2007-06-25

Please find attached our Taiwan Semiconductor CO.,LTD. PCN.

**“Chang Screw Hole for GBU Bridge Rectifiers Series”**

“Change screw hole for GBU product rectifiers series ”

**DESCRIPTION OF CHANGE:**

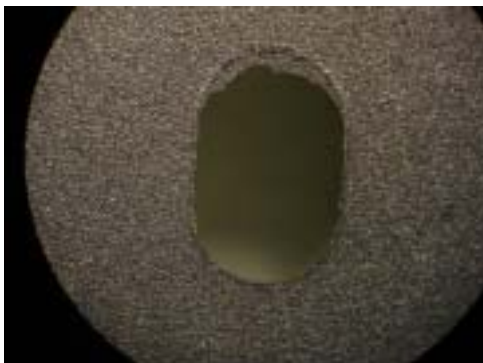
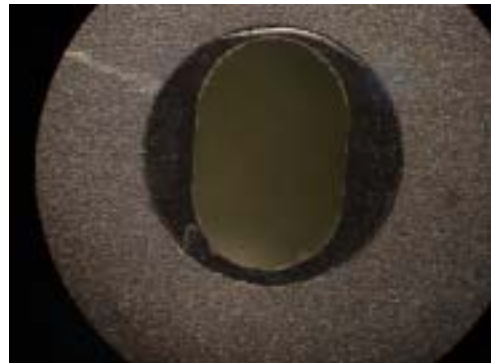
Improve the epoxy residual in the hole of GBU

Old: Before change

New: After change

**Old: Before change**

**New: After change**
